RE: Mullan Road Elementary School Modernization and Addition

ADDENDUM NO. 1

ADDENDUM NO. 1

DWG. NO.
E-06

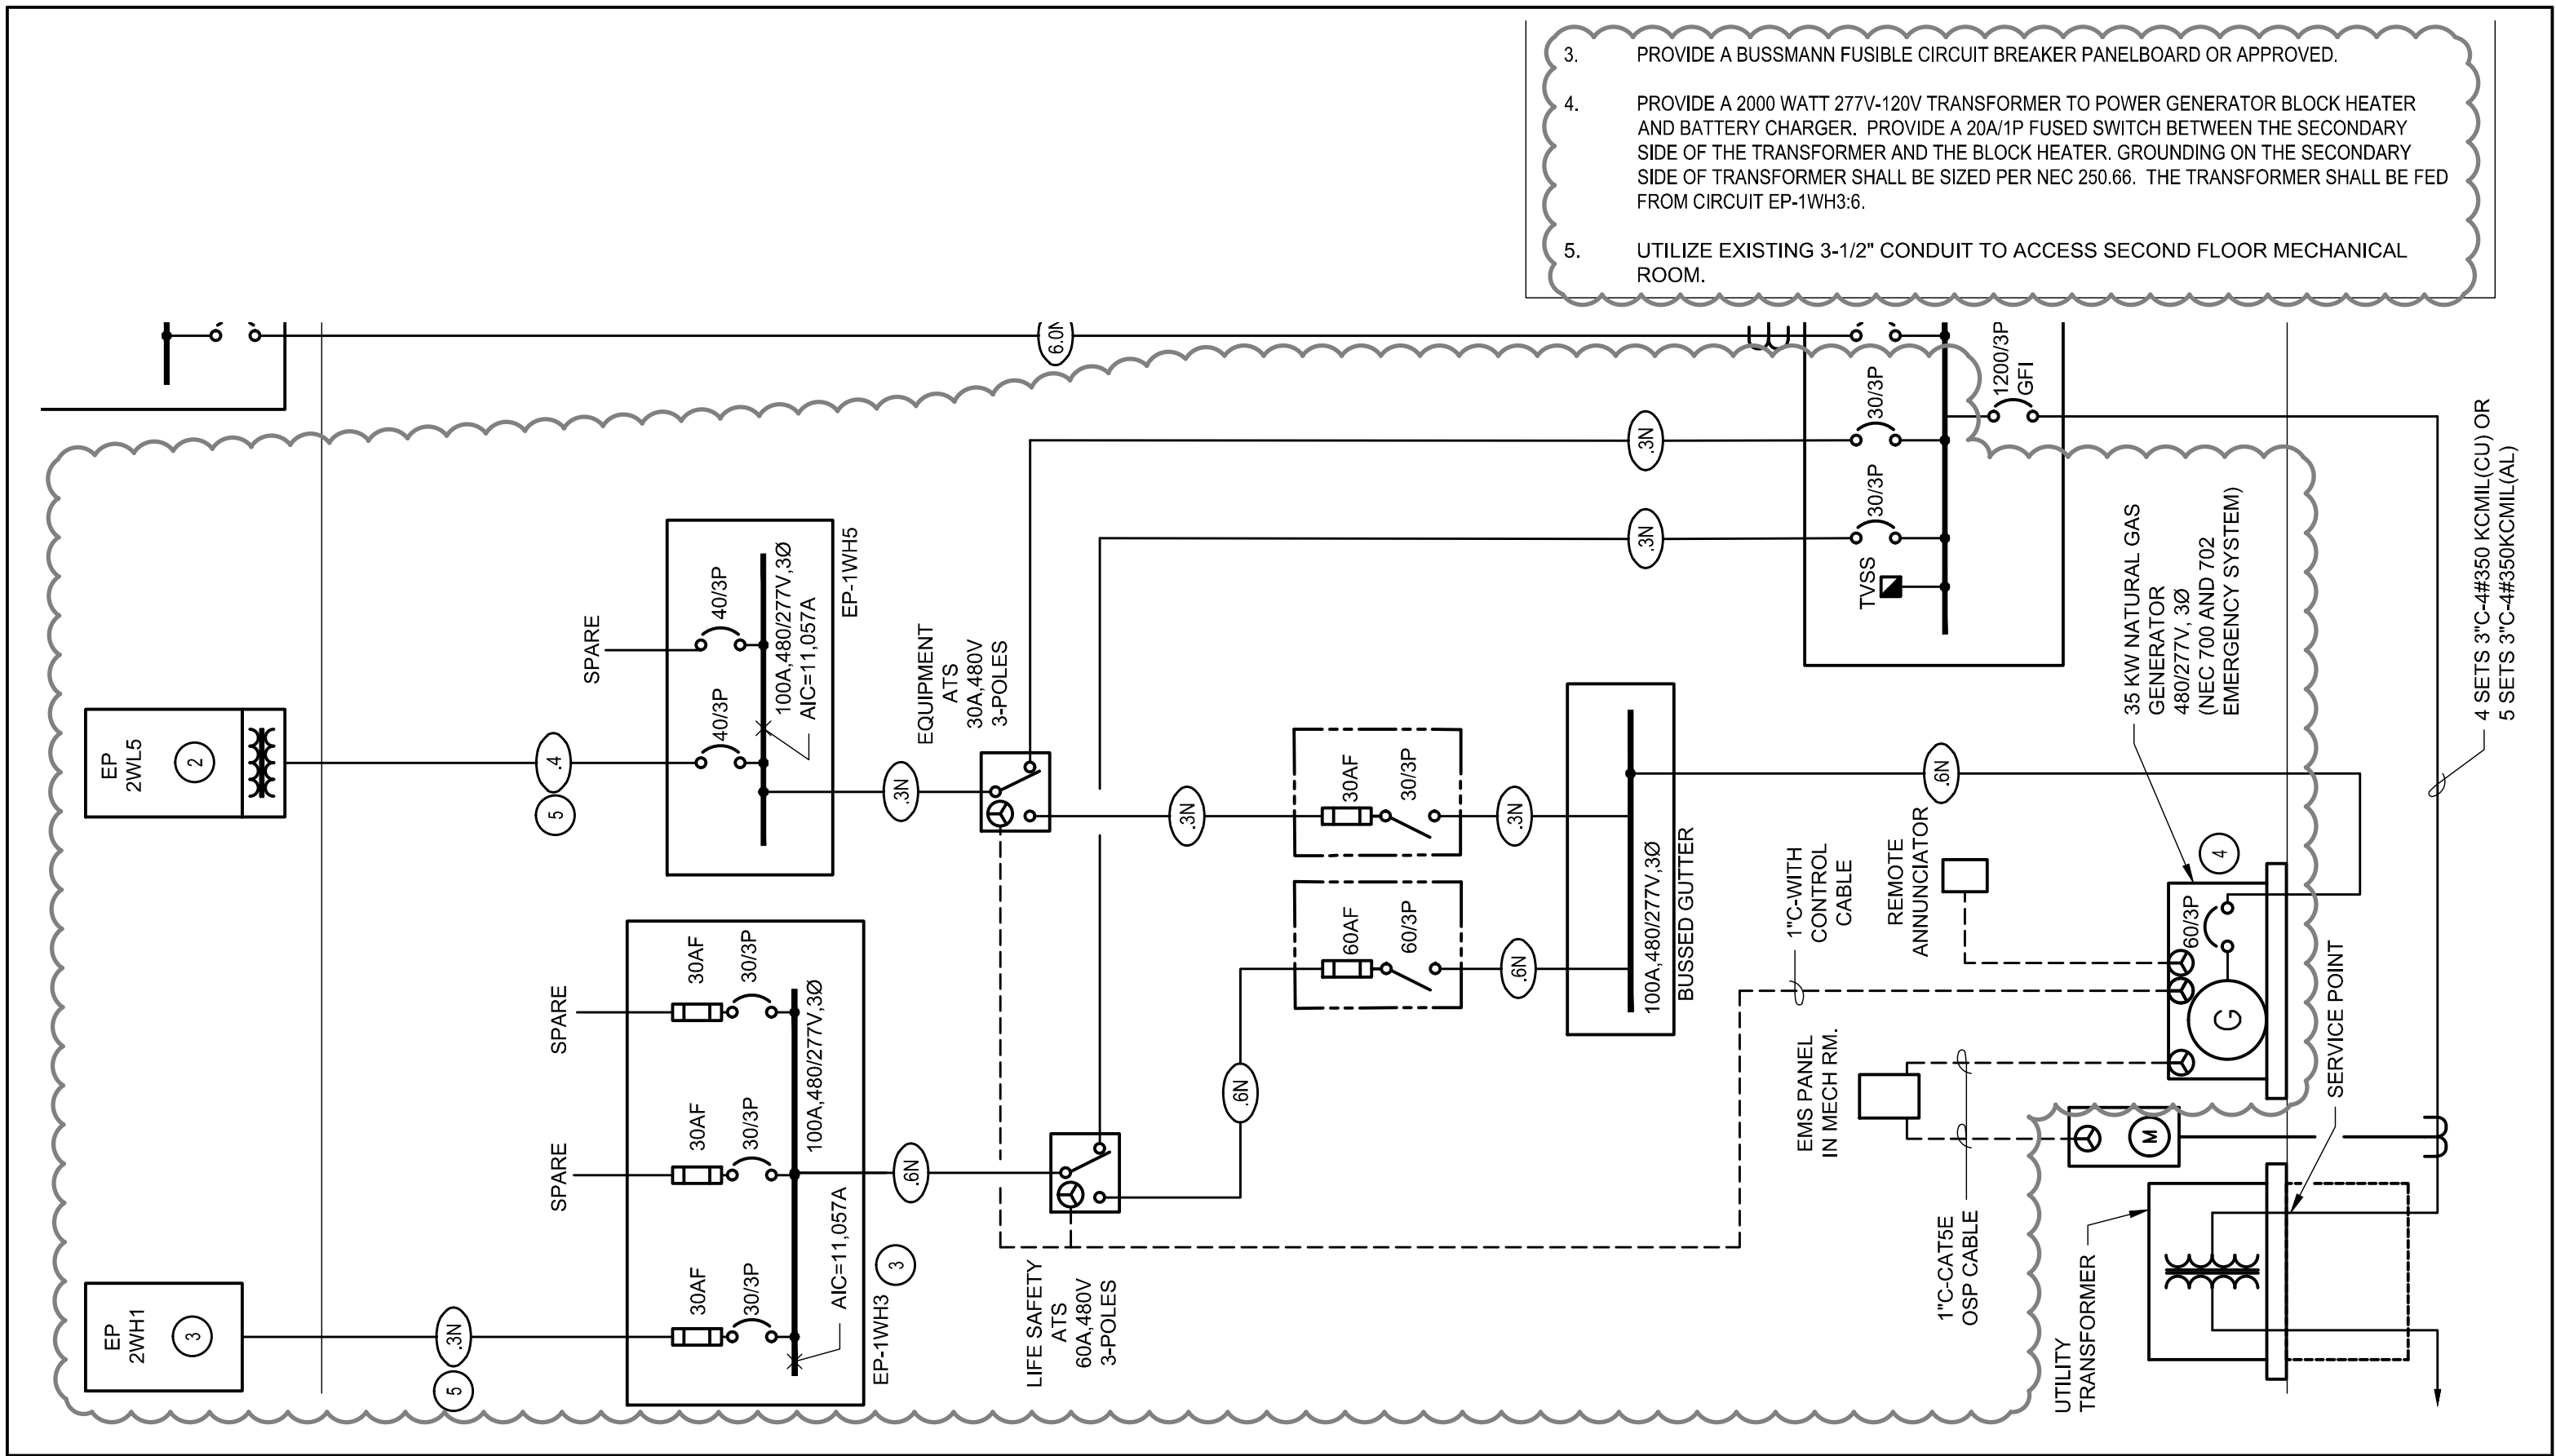
| 6. | Sheet E-709 | See attached clarification drawing E-06 for new panel schedules EP-1WH6. |
